Millstone Nuclear Power Station, Unit No. 2
Cycle 7 Refueling - Preliminary Reload Safety Analysis
Proposed Revisions to Technical Specifications

Millstone Nuclear Power Station, Unit No. 2

Cycle 7

Total Radial Peaking Factor vs Allowable Fraction of Rated Thermal Power

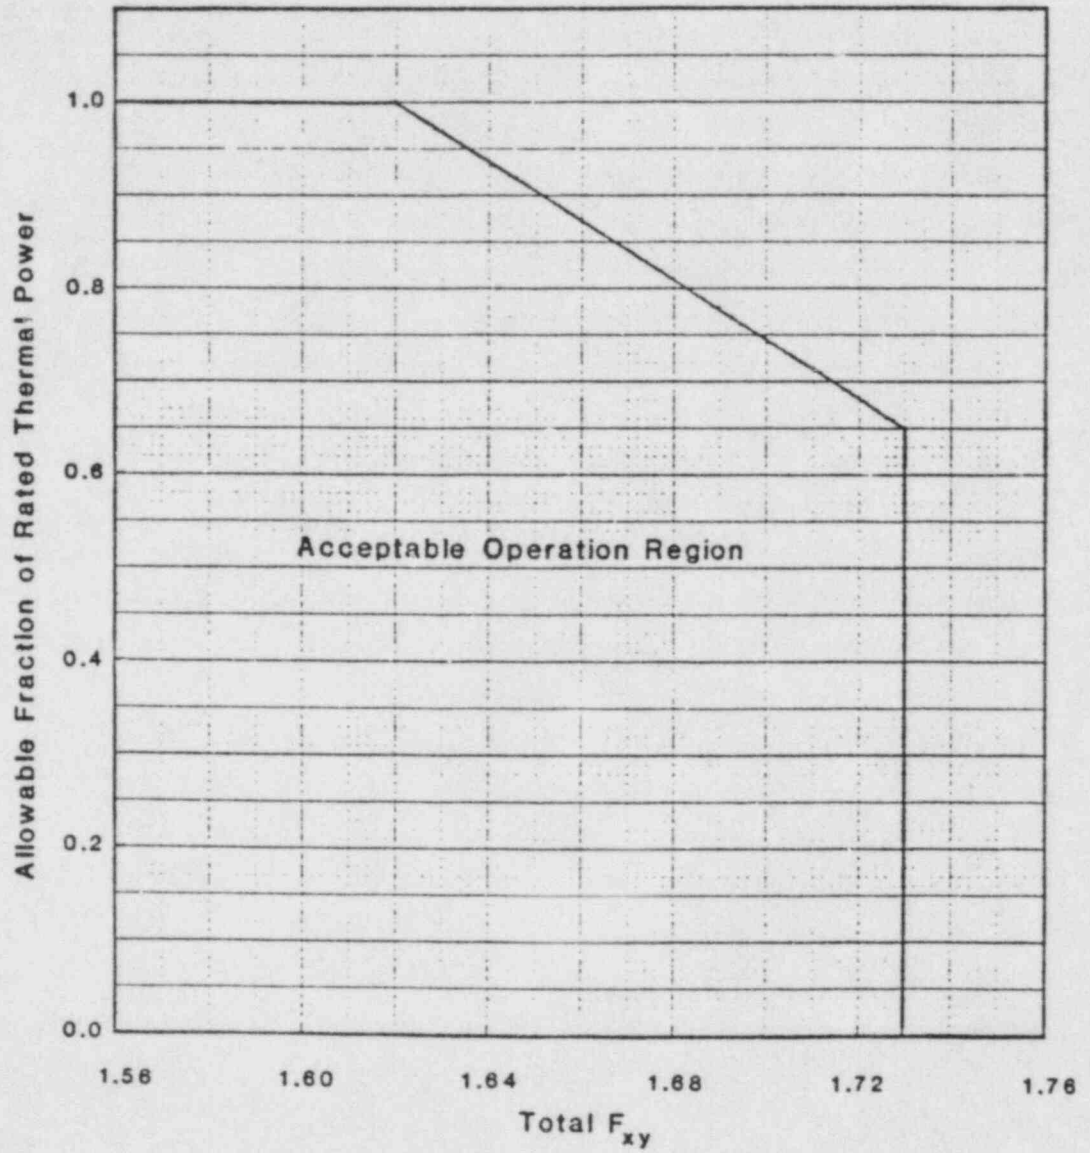
The Axial Shape Index (ASI) envelope currently used to monitor the linear heat rate while operating on excore detectors was generated using the power-dependent radial peaking factor (F_{xy}) given in Technical

Specification Figure 3.2-3 in accordance with the methodology described in Reference 2. The maximum F_{xy} allowed by the current Technical Specification is 1.719 at full power. The current envelope was verified to be unaffected by the proposed hardware change to the lead CEA bank as described in Section 3.1. An additional analysis was performed using the power-dependent F_{xy} shown in Figure 5, with a maximum of 1.62 at full power. The lead CEA bank hardware change was accounted for in the additional analysis. Given the F_{xy} relationship of Figure 5, the power shape analysis showed that it is acceptable to expand the ASI operating envelope to the limits shown in Figure 6. It is proposed that the surveillance requirements on the linear heat rate and the Technical Specification on the Total Planar Radial Peaking Factor (F_{xy}) be modified as given in the Appendix to allow the use of the wider operating range when F_{xy} is ≤ 1.62 .

FIGURE 6 Axial Shape Index vs Fraction of Allowable Power Level per Specification 4.2.1.2c

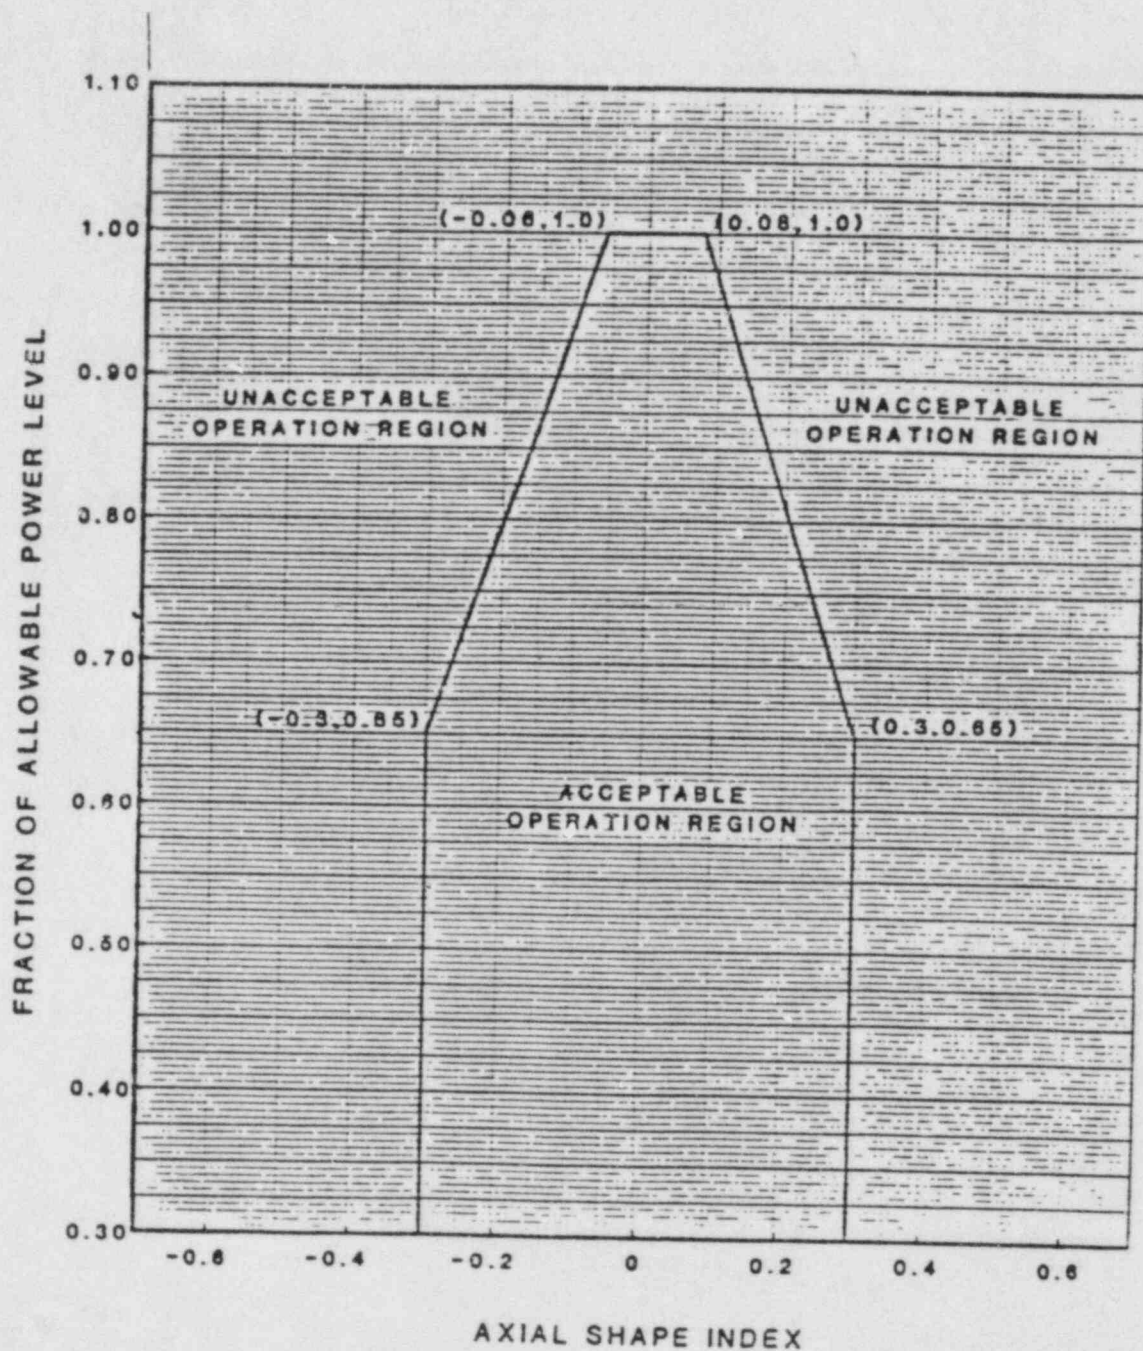
The curve of allowable thermal power vs axial shape index is used to assure that peak linear heat rate assumed in the LOCA analysis is not exceeded. For Millstone Unit No. 2, the maximum allowable peak linear heat rate is 15.6 kw/ft.

The proposed changes trade range in radial peaking for more range in axial shape index. The maximum radial peak is specified in the Technical Specification as a limit on F_{xy} . The maximum axial peak is specified by limits on the axial shape index. The allowable axial shapes will still assure that the limit on maximum peak linear heat rate of 15.6 kw/ft. is met. The increase in the allowable value of the axial shape index will be offset by a decrease in the allowable value for F_{xy} without changing the design basis value for linear heat rate. Since the design basis value for linear heat rate is unchanged, safety analyses involving linear heat rate are not impacted by the change.
